# *City of Brisbane*

## *Planning Commission Agenda Report*

**SUBJECT:** **Sign Program Modification SR-1-20 (Amendment to SR-7-19);** Sign Program Modification to “The Shore at Sierra Point Sign Program” for the HealthPeak Biotechnology Research and Development Campus; 800 to 1800 Sierra Point Parkway; Kevin Norman, DES Architects + Engineers, Inc., applicant; Scott Bohn, HealthPeak Properties, owner

**Sierra Point, Brisbane, CA.**  
Signage Master Plan

**R&D BUILDING WALL SIGNAGE: CONNECTOR ELEVATIONS**

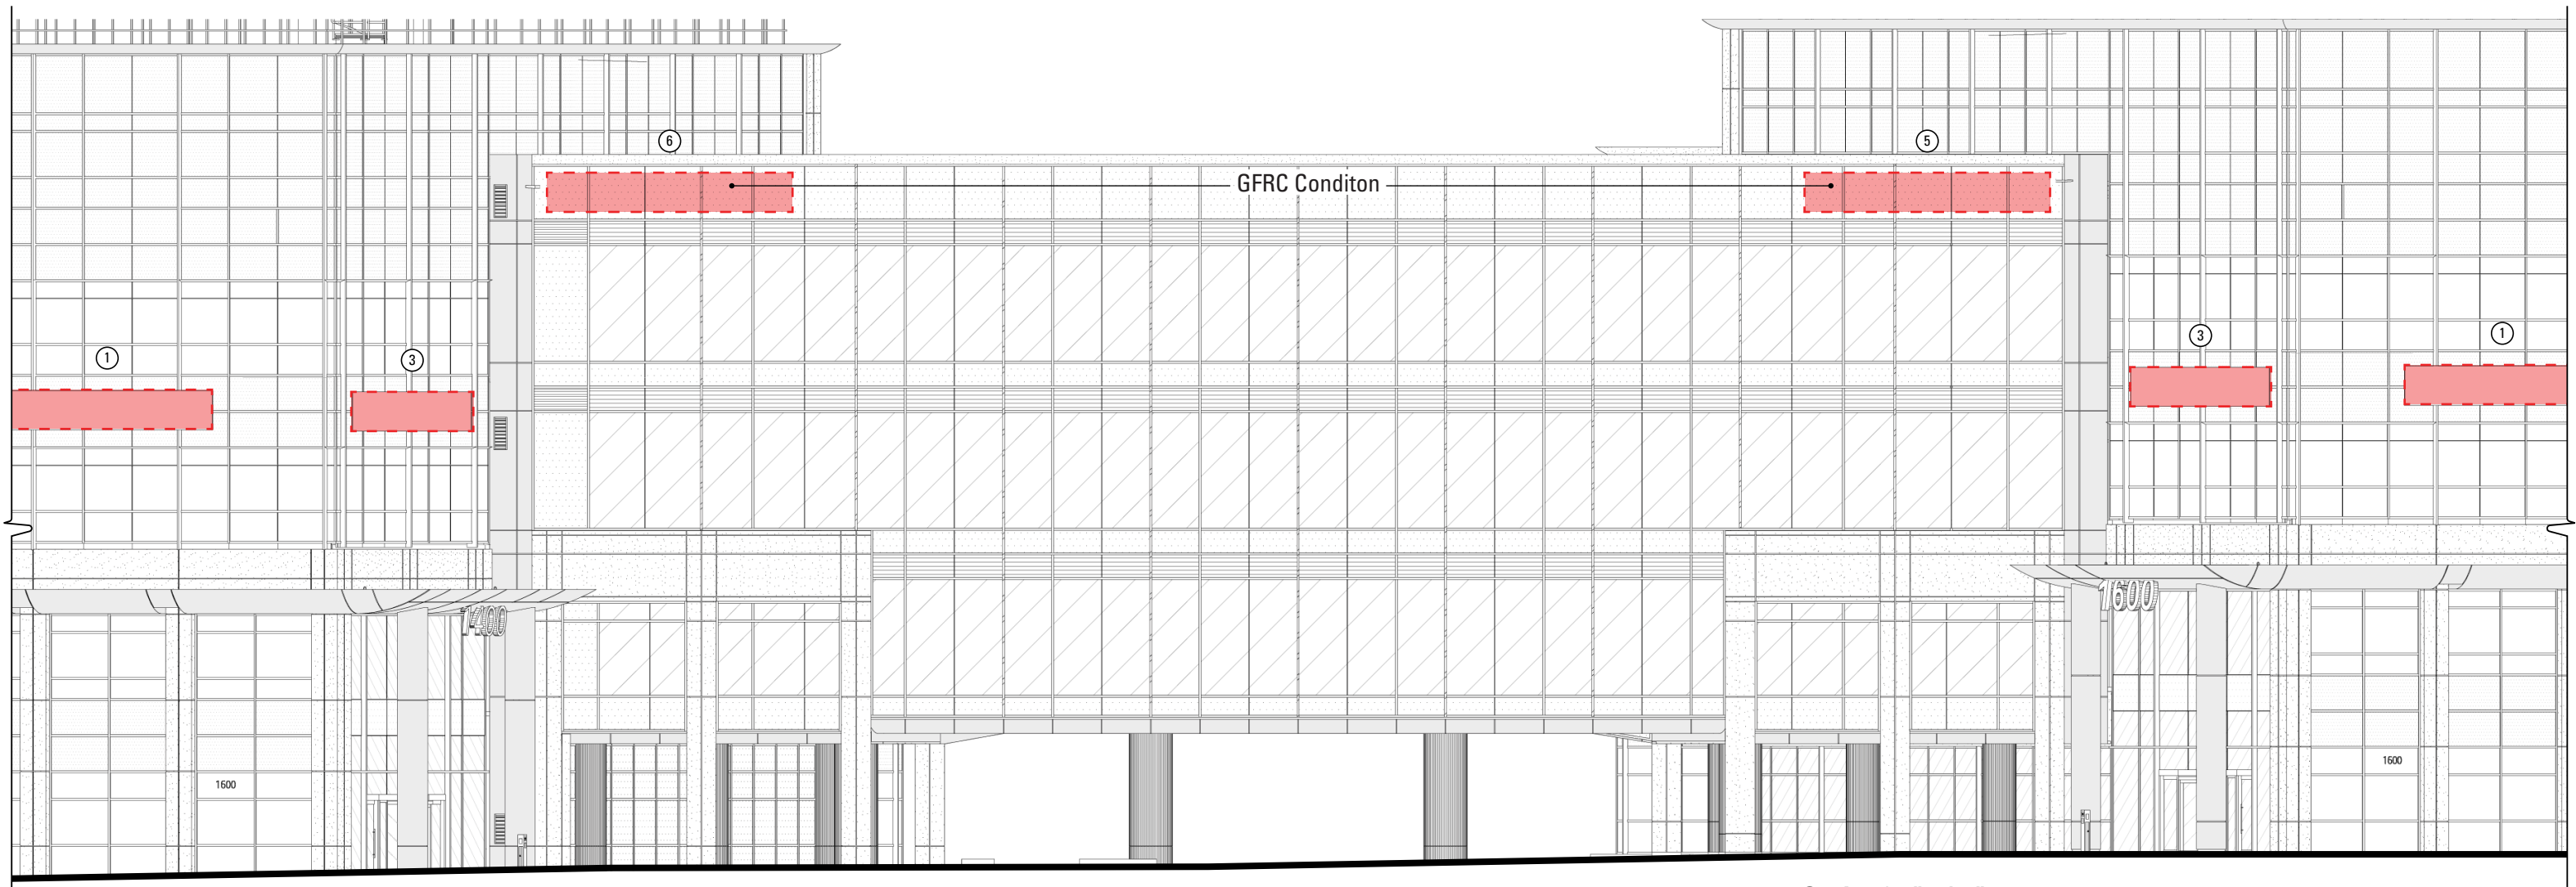
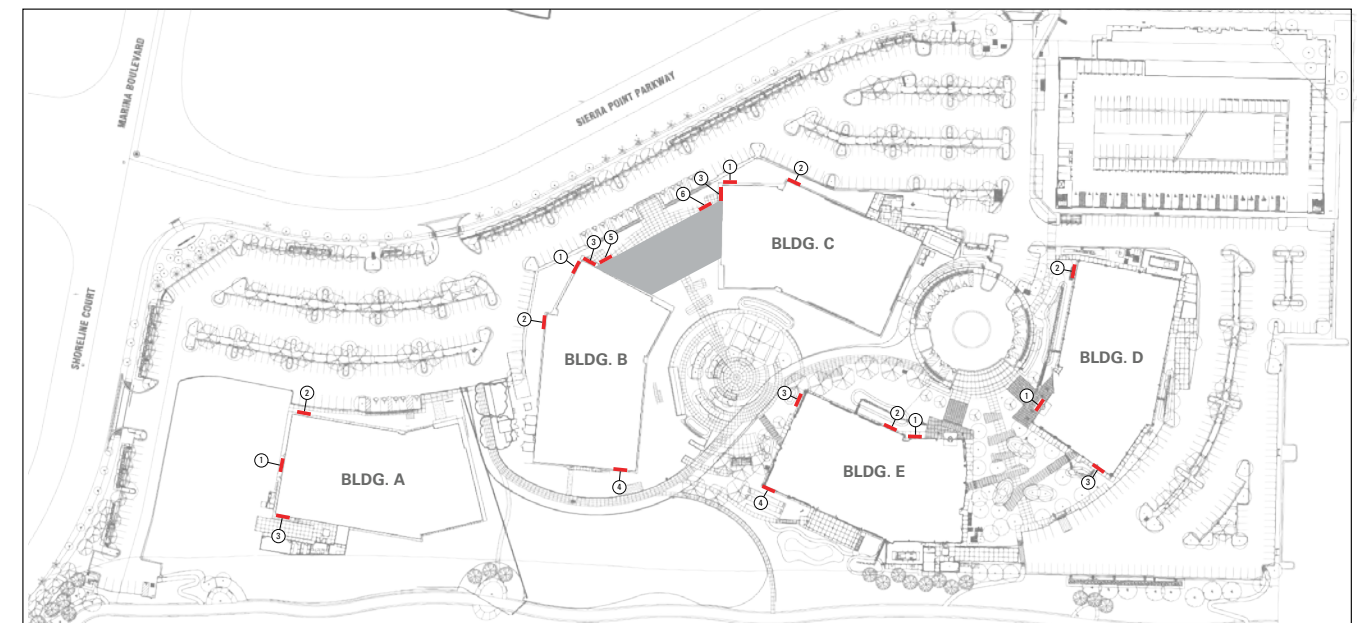
Updated to Include Connector Bldg  
between 1400 and 1600 Sierra Point  
Parkway - 7/22/21

North Elevation: B1, B3, B5, B6, C1, & C3 25' x 4', mounted to building facade

**R&D BUILDING WALL SIGNAGE: BLDG C ELEVATIONS**

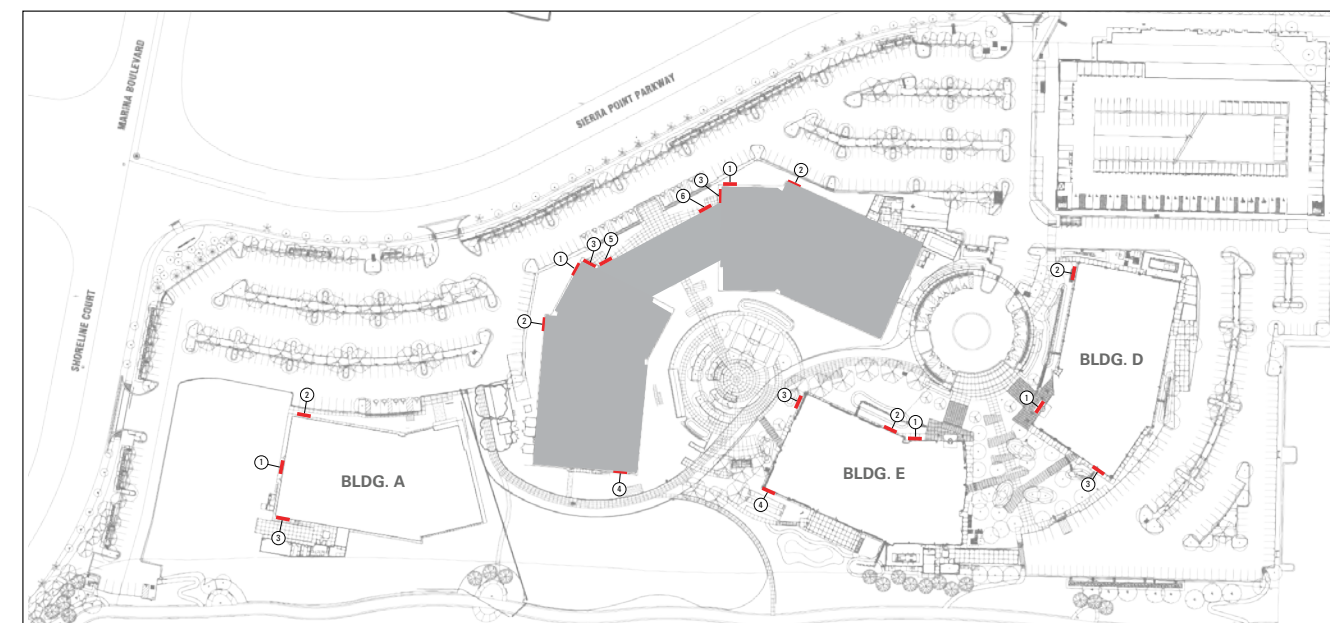
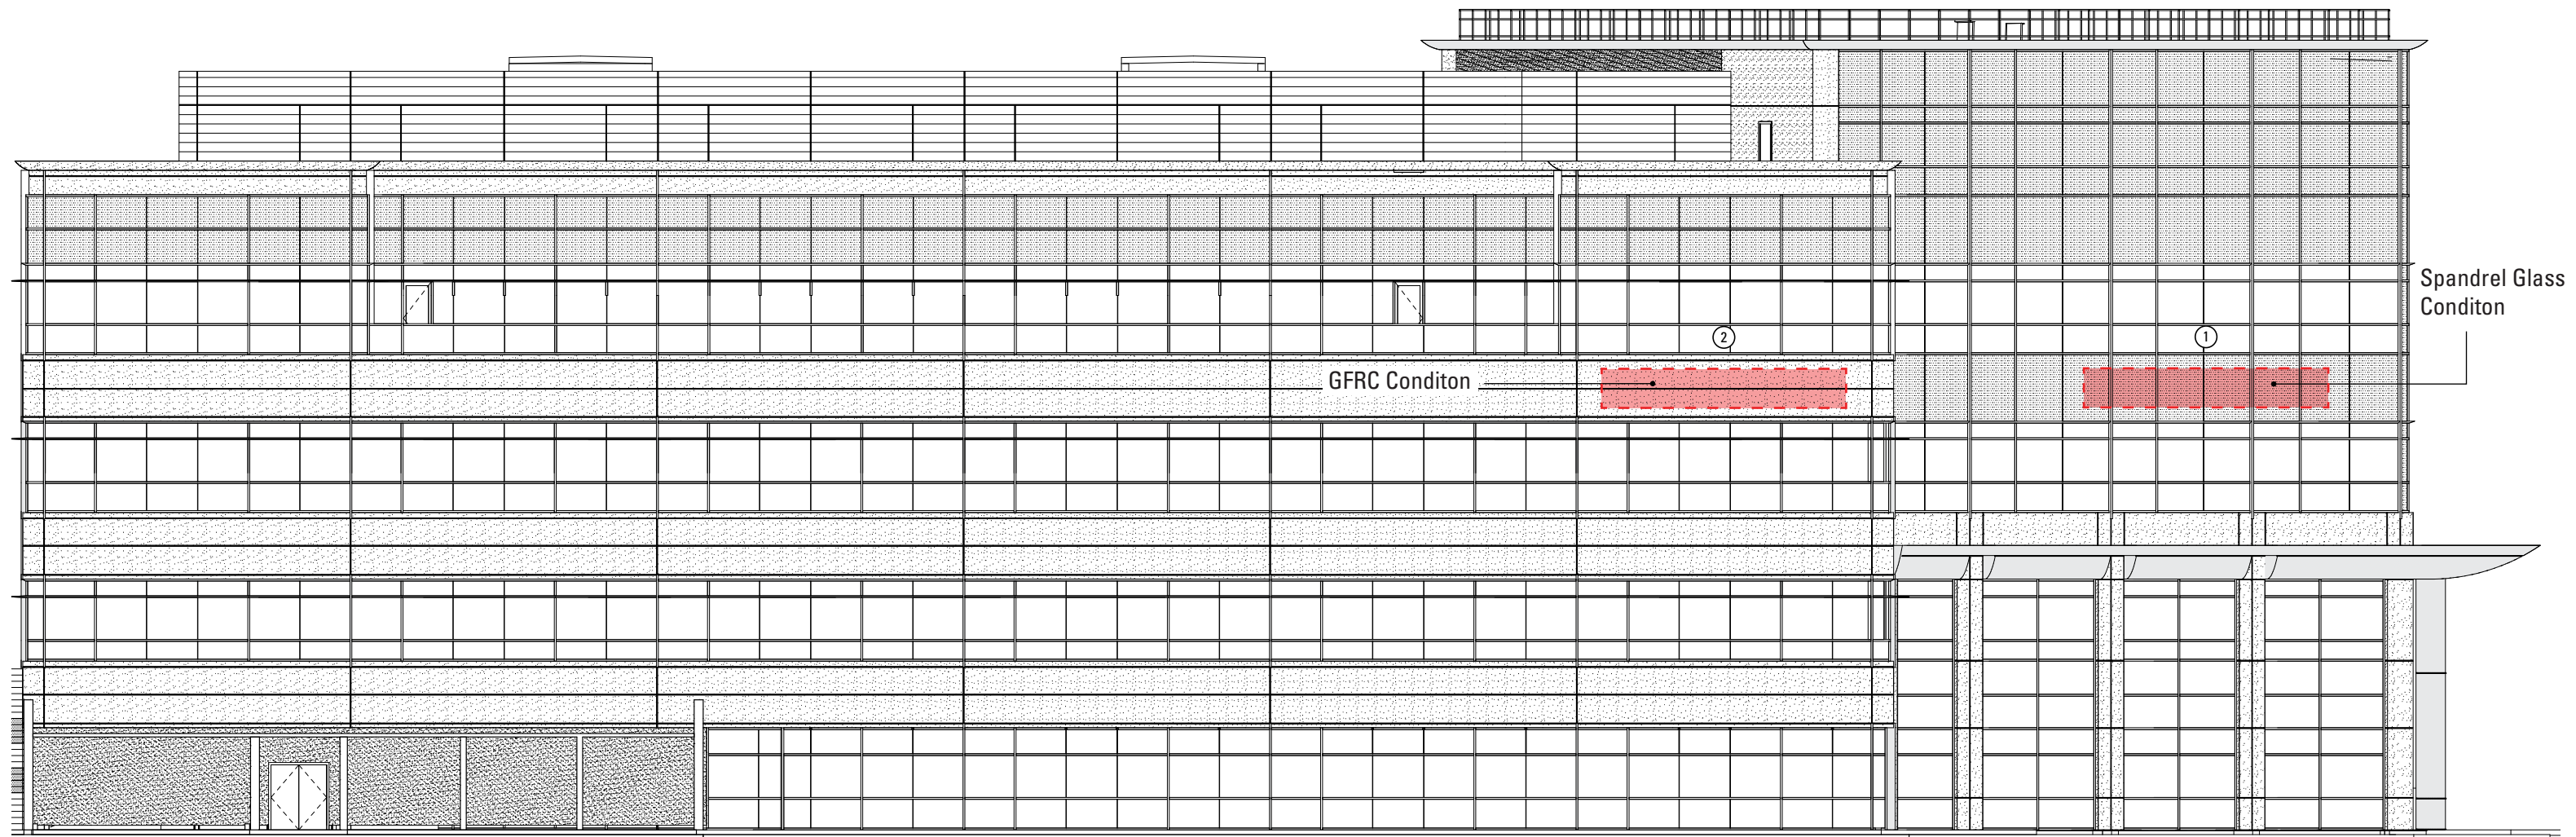
Added to Include Connector  
Bldg between 1400 and 1600  
Sierra Point Parkway - 7/22/21

Updated to Include Connector Bldg  
between 1400 and 1600 Sierra Point  
Parkway - 7/22/21

North Elevation: C1 & C2: 25' x 4', mounted to building facade

**R&D BUILDING WALL SIGNAGE: BLDG C ELEVATIONS**

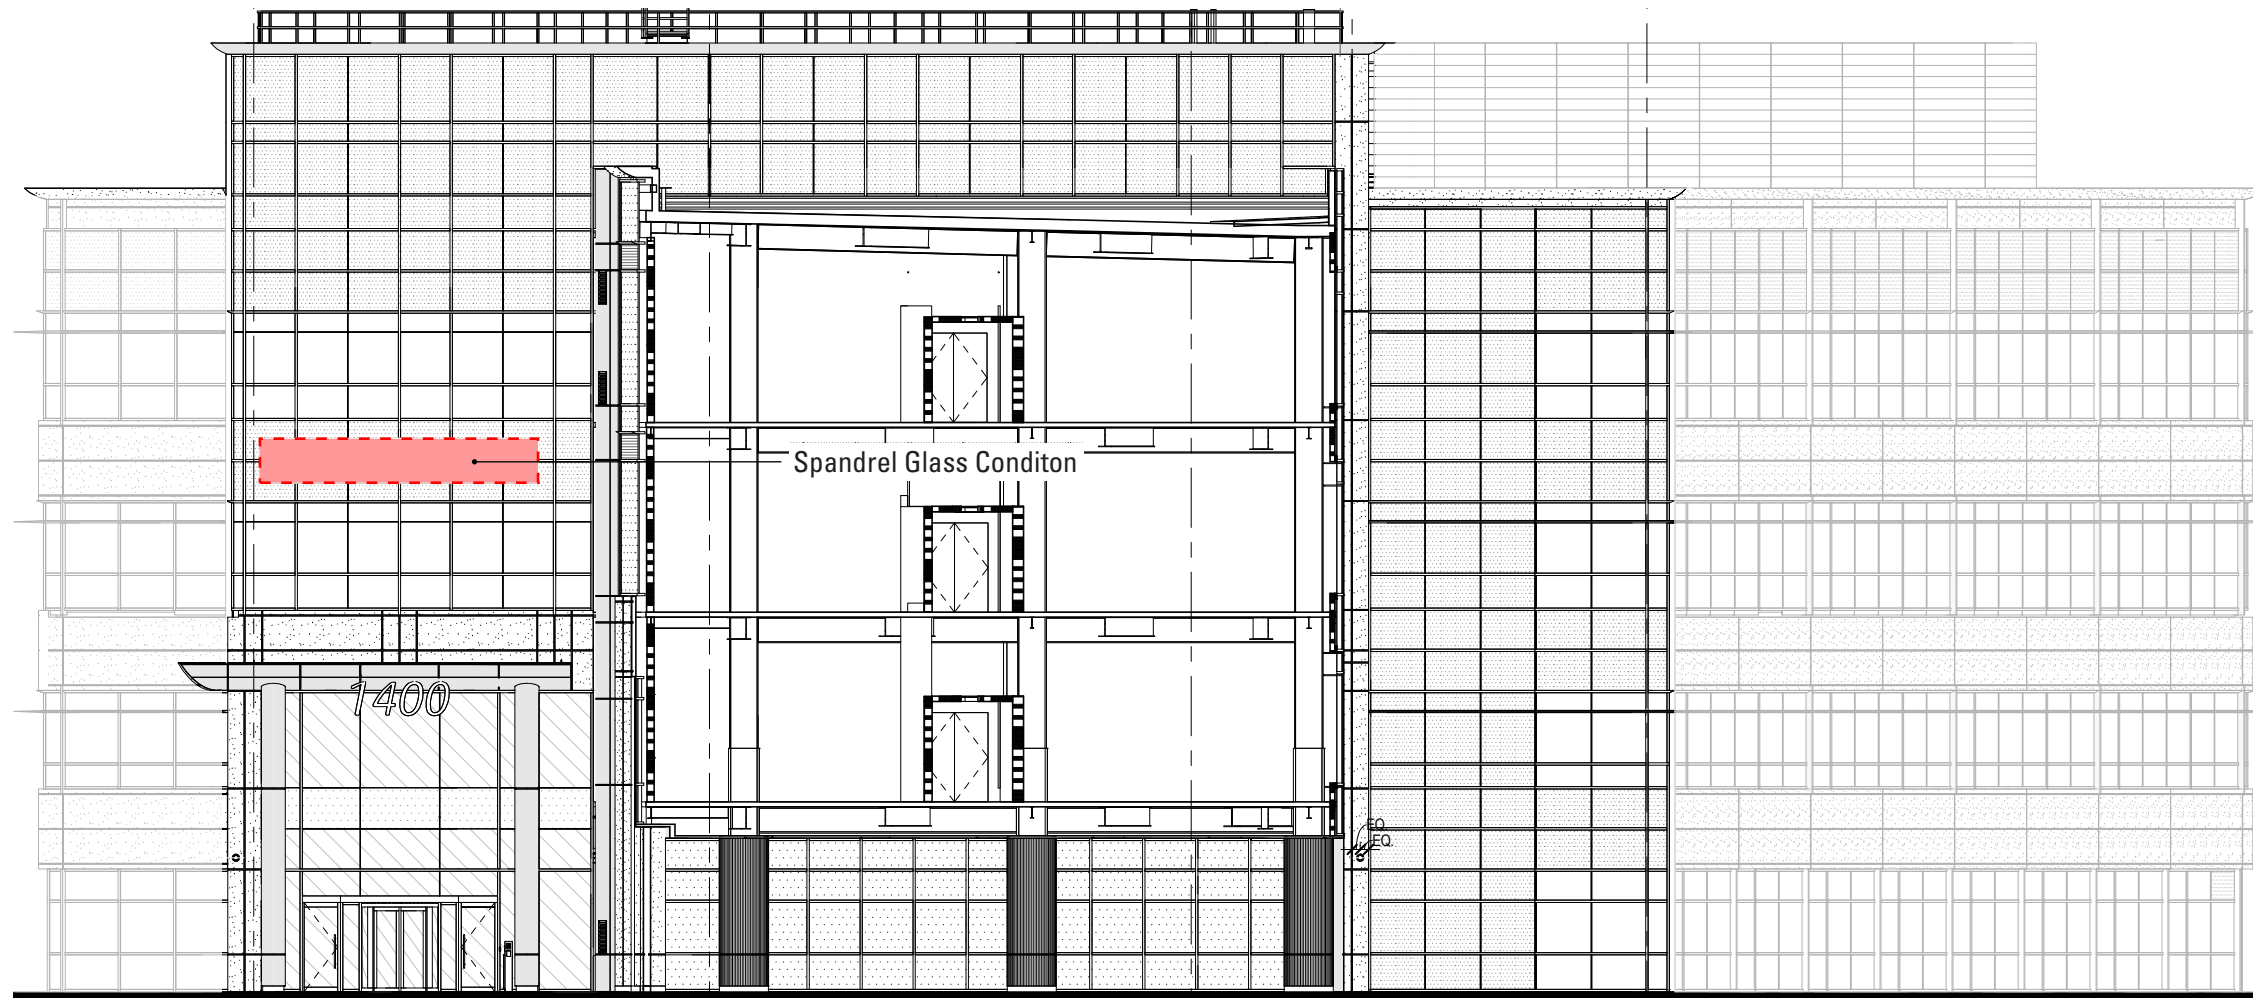
Updated to Include  
Connector Bldg between  
1400 and 1600 Sierra  
Point Parkway - 7/22/21

West Elevation: C3: 25' x 4', mounted to building facade

**TENANT SIGN LOCATIONS**

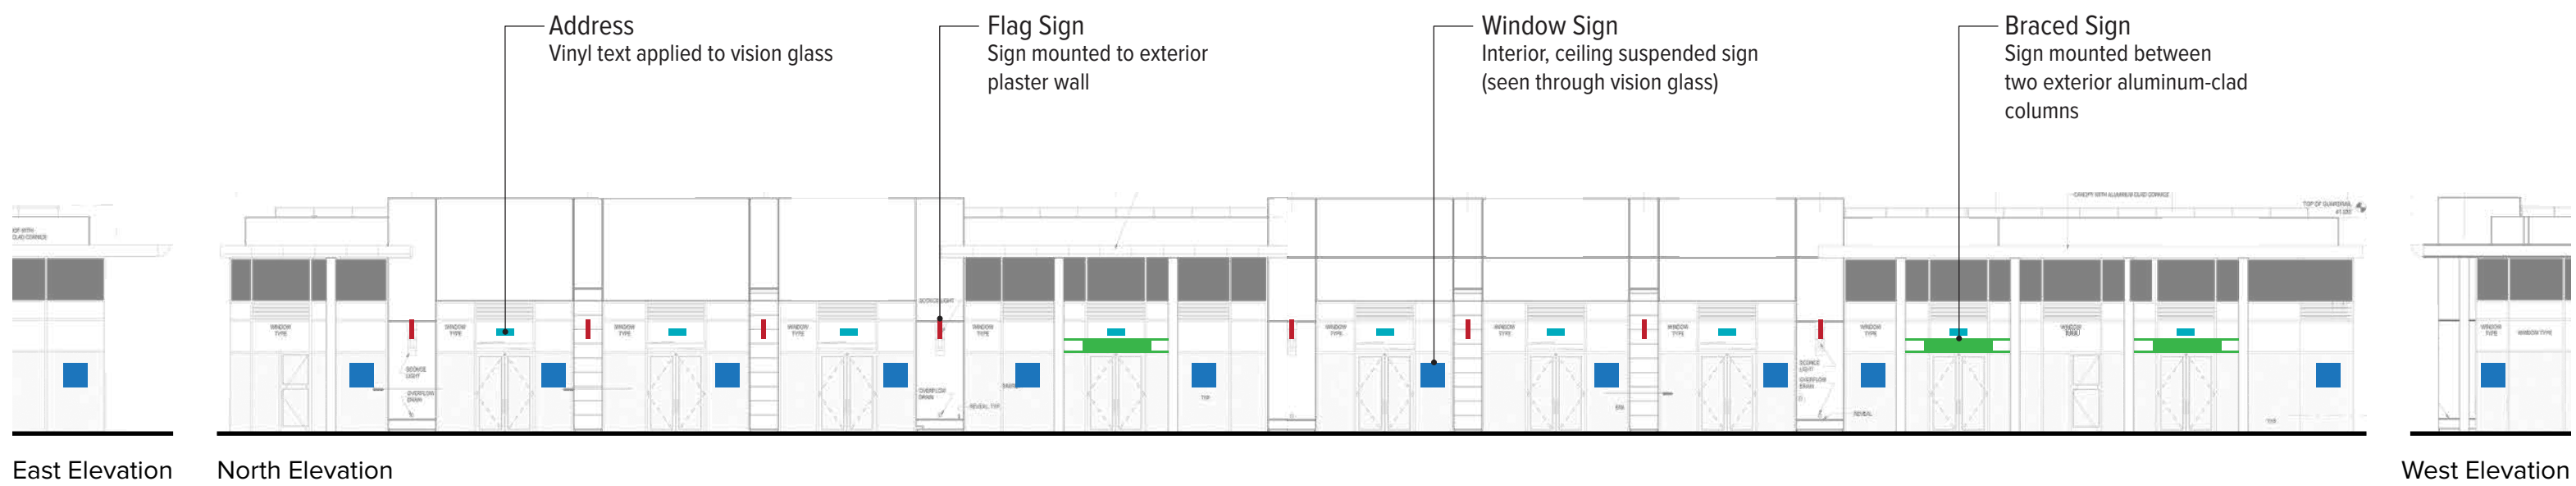
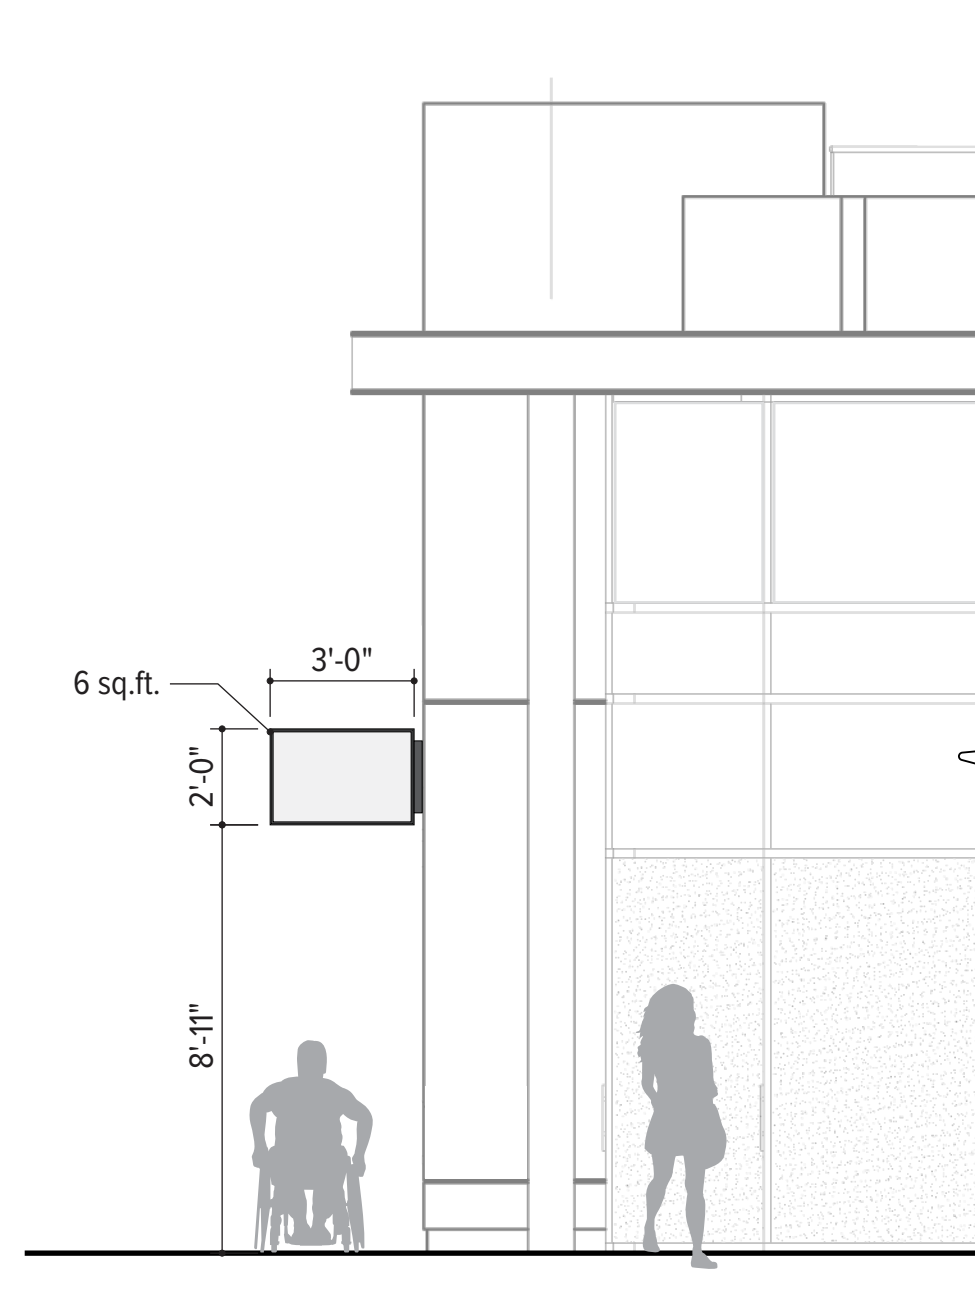
**Entire Section Added - 7/22/21**

Each tenant to be limited to one Flag or Braced sign, one Window sign, and one Address sign, for a maximum of three signs per tenant. In the case that a tenant occupies more than one adjacent entry door, only one address will be used.
